9 Lincoln's Inn Fields

2020/3856/P & 2020/4718/L

Delegated Report (Members Briefing)		Analysis sheet		Expiry Date:		19/10/2020			
		N/A		Consultation Expiry Date:		15/11/2020			
Officer				Application Number(s)					
Mark Chan				1) 2020/3856/P 2) 2020/4718/L					
Application Address				Drawing Numbers					
9 Lincoln's Inn Fields London WC2A 3BP				Please refer to draft decision notice					
PO 3/4	Area Team Signature	C&UD	Authorised Officer Signature						
Proposal(s)									
Installation of 2x air conditioning (A/C) units in the rear enclosed courtyard of the building, and 5x internal wall mounted A/C cassettes.									
Recommendation(s):		1) Grant conditional planning permission 2) Grant conditional listed building consent							
Application Type:		1) Full Planning Permission 2) Listed Building Consent							
Conditions or Reasons for Refusal:		Refer to Draft Decision Notice							
Informatives:									
Consultations									
Adjoining Occupiers:		No. of responses		0		No. of objections		0

Internal courtyard / lightwell

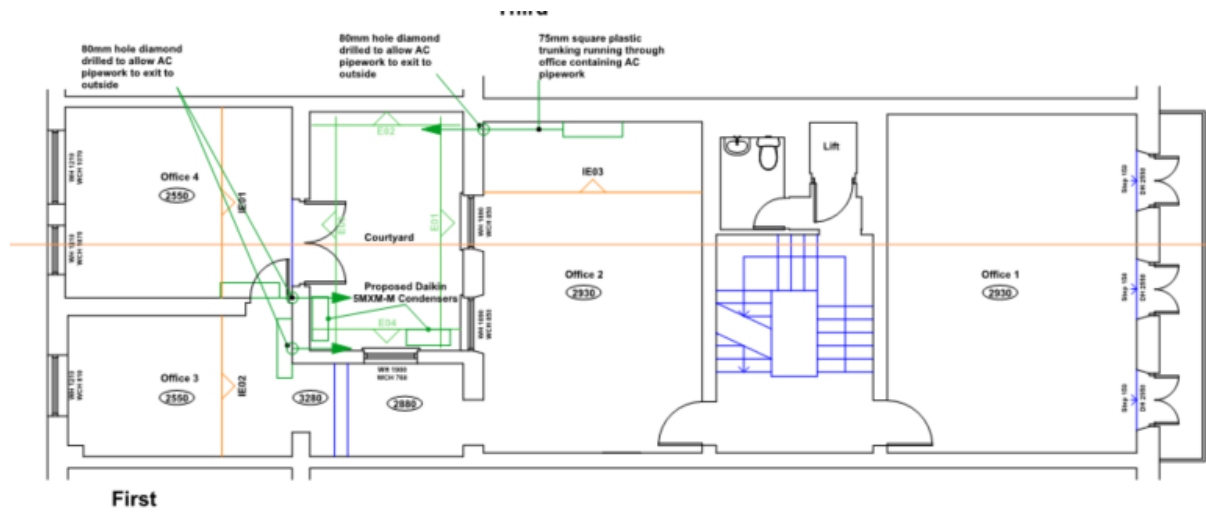
2.2.5 As can be seen from the aerial view above, the units would be in the courtyard/lightwell which is sunken down between the main building and the extension. The proposed units would not be visible in short or long views from the public realm. The impact of the proposed units is reduced further by their relatively small size and the proposed units would not cause harm to the character and appearance of the conservation area given their size and limited visibility.

Proposed elevations

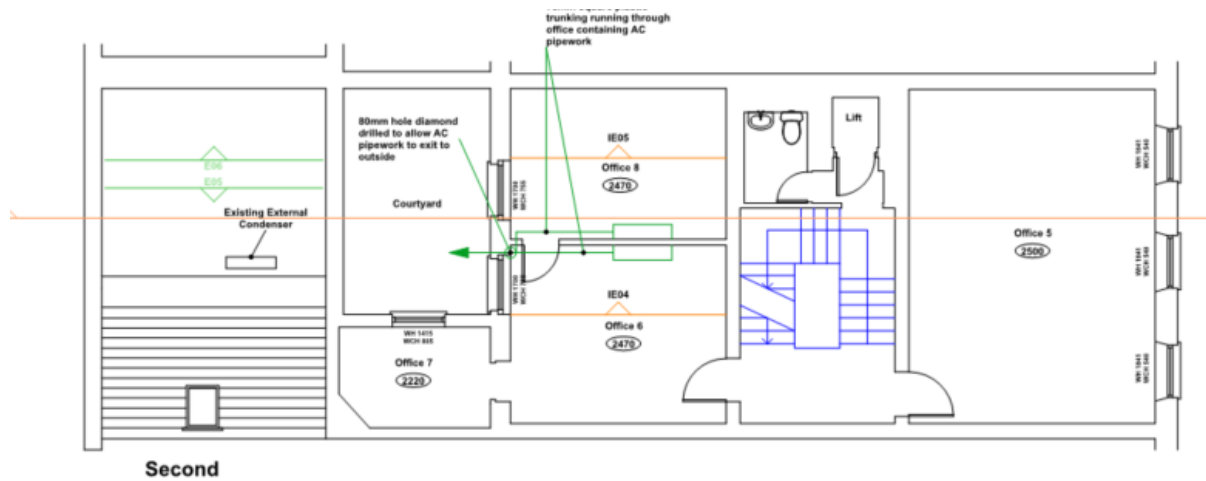
This kind of thing just shouldn't be acceptable on a listed building, I'm not sure whether the internal courtyard is any better to be honest, perhaps even worse in terms of heritage.

Obviously the impact upon the CA is less but the impact upon the listed building greater. It'd be poor design on a non-listed building never mind in this sort of context.

The Officer does not considered there to be harm to the conservation area, or the listed building. See section 2.2 of the report for detail.
